# Access Compliance Report

## Public Rights-of-Way

### (Pedestrian Signals)

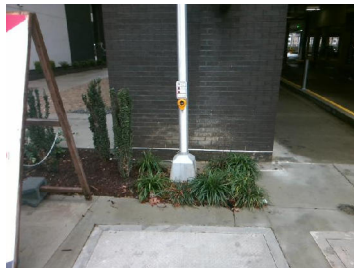
Intersection ID: N/A	Main Street:	Cross Street: N/A	Location: N/A
ADA ID: 56DCA38EBD2A	Signal Type: One Push Button-APS	Overall Compliance: No	Severity Score: BTN 1: N/A BTN 2: N/A No BTN: N/A
Codes/Mitigation Info/Possible Solution		Field Measurements/Component Compliance

PROW/ADA: TMUTCD 4e.08, R406.2, R404.7.3

Possible Solutions: Replace Signal Push Button With APS Button on New Post. Remove & Relocate Sign.
